Minutes of the North Carolina Building Code Council
March 11, 2013
Raleigh, NC

Part A – Administrative Items

Part B – New Petitions for Rulemaking

Part D – Final Adoption

SECTION VIEW OF METAL FRAME ROOF:
FILLED CAVITY FIBERGLASS INSULATION

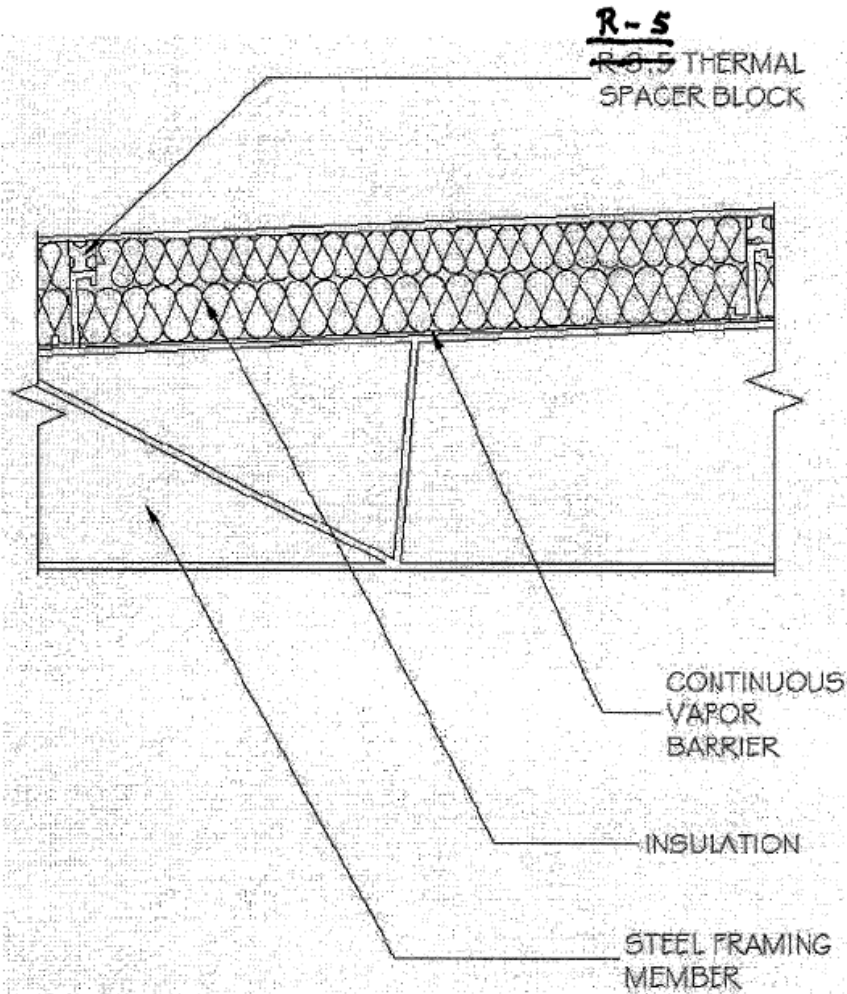
Item D – 2 Request by Daniel J. Walker, PE, with the Metal Building Manufacturers Association, to amend the 2012 NC Energy Code, Tables 502.1.2, 502.2(1), and 502.2(2), and Appendix 2.2. The proposed amendment is as follows:

ROOFS	DESCRIPTION
R- 11 10 + R-19 FC	Filled cavity fiberglass insulation. A continuous vapor barrier is installed below the purlins and uninterrupted by framing members. Both layers of uncompressed, unfaced fiberglass insulation rest on top of the vapor barrier and are installed parallel, between the purlins. A minimum R-3.5 thermal spacer block is placed above the purlin/batt, and the roof deck is secured to the purlins. Drawings of typical details are shown in Appendix 2.2.

Revise Appendix 2.2 as follows:

Motion – Ralph Euchner/Second – Bob Ruffner/Adopted unanimously with modifications.
